8510 WALKERS FERRY RD

Groundwater & Wastewater Services
Well Project File & Data Review Worksheet

WELL ABANDONMENT RECORD

Rept. for ARGU Review
8510 Walkers Ferry Rd., **Charlotte, NC**
PID# 113-**361**-33
File # 69890**B**
Application#1980

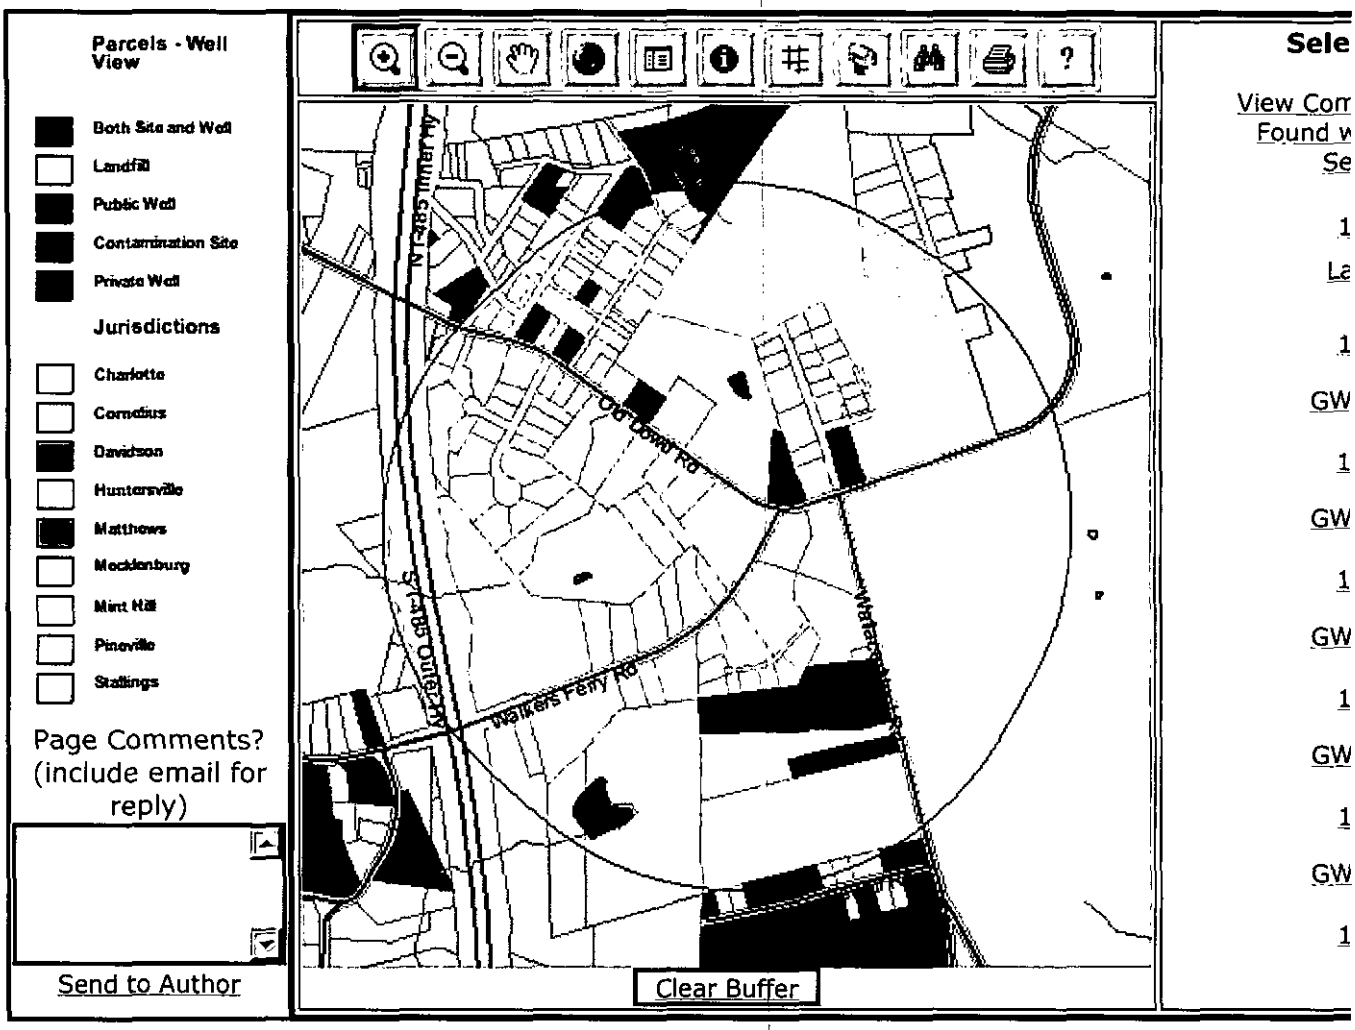
03/05/07 (Mon.) - Conducted ARGU Review. Identified 1 MPL site within 2,000' of the subject parcel.

MPL# 1069 Charlotte/Douglas International Airport
7200 Old Dowd Rd., Charlotte, NC
PID# 113-093-33
LCIDP LF

File review for Charlotte/Douglas International Airport indicates this is an open private permitted land clearing and inert debris landfill.

NOTE: Mandatory setback for a new well is 100-ft from a LCIDP LF.

The closest parcel boundary for the subject site is more than 1,500' from the parcel boundary for the landfill.

Based on review of our files, the permit for a private well abandonment at PID# 113-361-33, 8510 Walkers Ferry Rd., Charlotte, NC is approved. The referenced MPL site is outside of the ARGU and more than 100' from the well location, the setback required for a LCIDP LF, so the well requires abandonment under the Mecklenburg Co. Groundwater Regulations dated Oct. 5, 2004, Chapter II Construction, Repair and Abandonment for Private Water Supply Wells with no special conditions.
